From: Phil Inglis [jinglis@erols.com]
Sent: Monday, December 04, 2006 4:35 PM
To: PCTEST TCB
Cc: PCTEST - Al Cirwithian; PCTEST - Andrea Zaworski; PCTEST - Courtenay Geraghty; PCTEST - Gregory Czumak; PCTEST - Randy Ortanez
Subject: Re: Question Regarding FCC ID: MHATMS1
Attachments: SCREN235.GIF

> To: Mr. Phil Inglis / TRPFrom: Mr. Gregory Czumak / PCTEST
> TCBRE: FCC ID: MHATMS1
>
> Applicant: Data Sciences International
>
> Correspondence Reference Number: MHA0770 Confirmation Number: 11270770
> Date of Original Email: December 01, 2006
> Subject: Request for additional information<?xml:namespace prefix = o
> ns = "urn:schemas-microsoft-com:office:office" />In regards to your
> recent TCB application referenced above, we kindly request that you
> provide the following additional information.
>
> 1. Please verify that the loop antenna was rotated 360 degrees on its
> vertical axis, and also placed horizontally, in an effort to maximize
> the emissions.
>
> 2. Please verify that the EUT was tested in 3 orthogonal planes.
>
> 3. There is a Restricted Band (per Section 15.205) at 8.291 –
> 8.294 MHz. The occupied bandwidth plot submitted in the test report
> appears to show that a

SCREN235.GIF (16 KB)

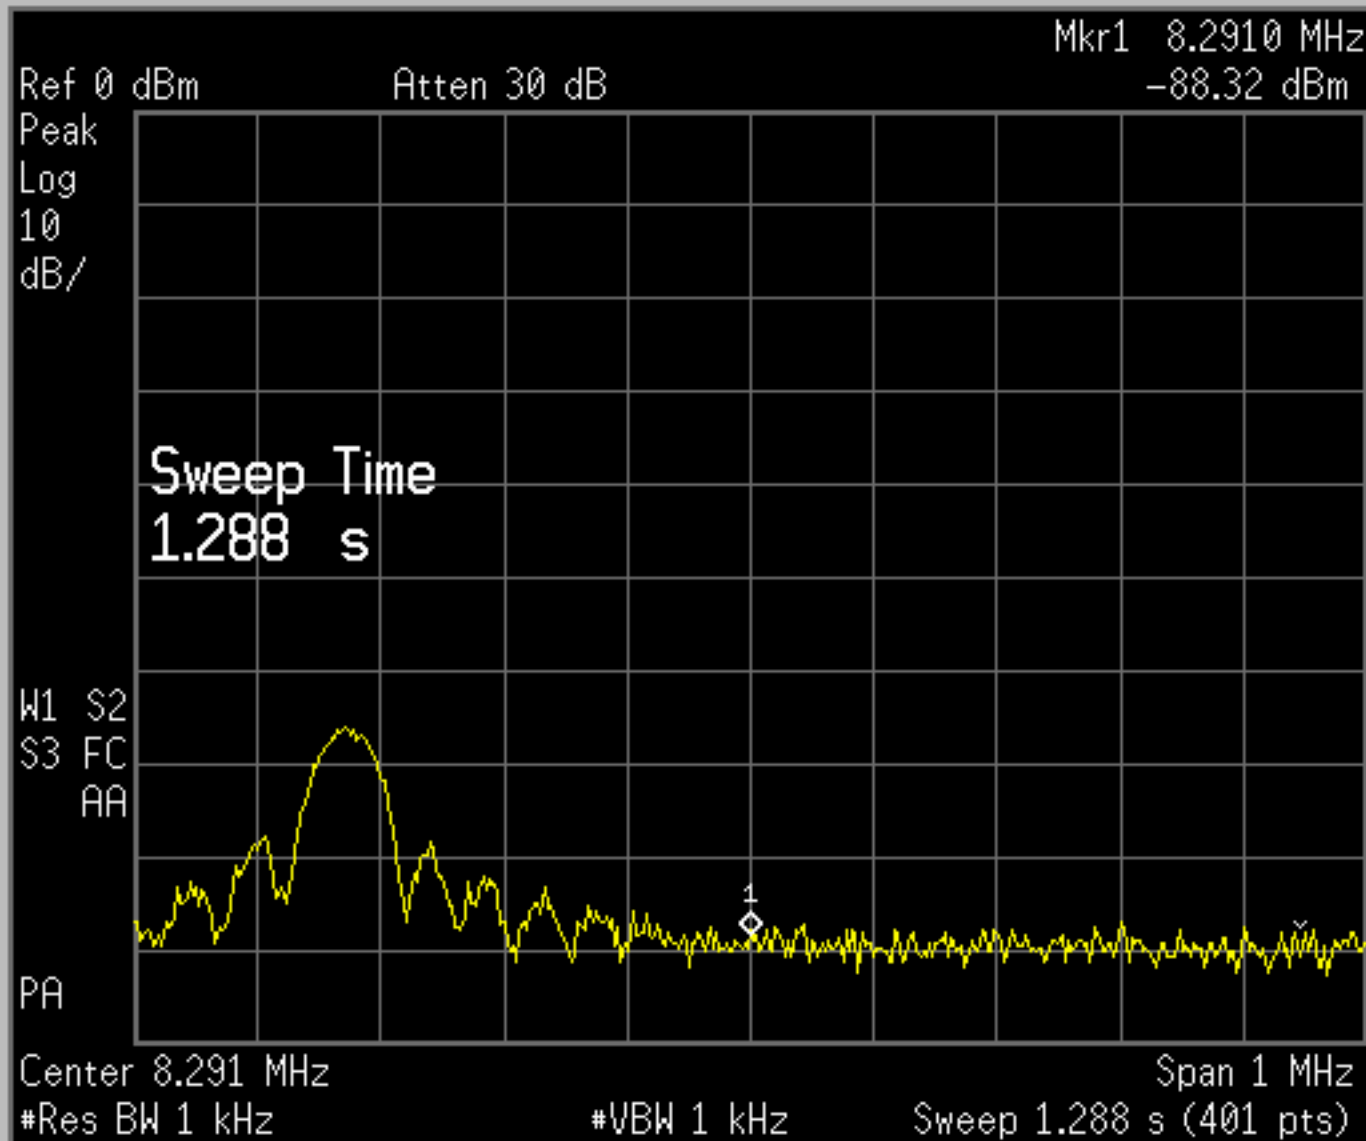
> this band. Please remeasure using a narrower RBW (still greater than
> 1% of the occupied bandwidth), and show its relation to the referenced
> Restricted Band, and submit the new plot.

1. This correspondence is to verify that the loop antenna has been confirmed to have been rotated 360 degrees on it's vertical axis and also placed horizontally in an effort to maximize the emissions.
2. This is to also verify that the EUT was tested in 3 orthogonal planes.
3. Please find the attached plot showing there are no modulation products at or above the restricted band edge starting at 8.291 MHz from the product and compliance with the FCC rules is shown. It is noted that Industry Canada has a requirement to list the emission designator on their grant. For Industry Canada it is acceptable to use 250KA1D as the emission designator.
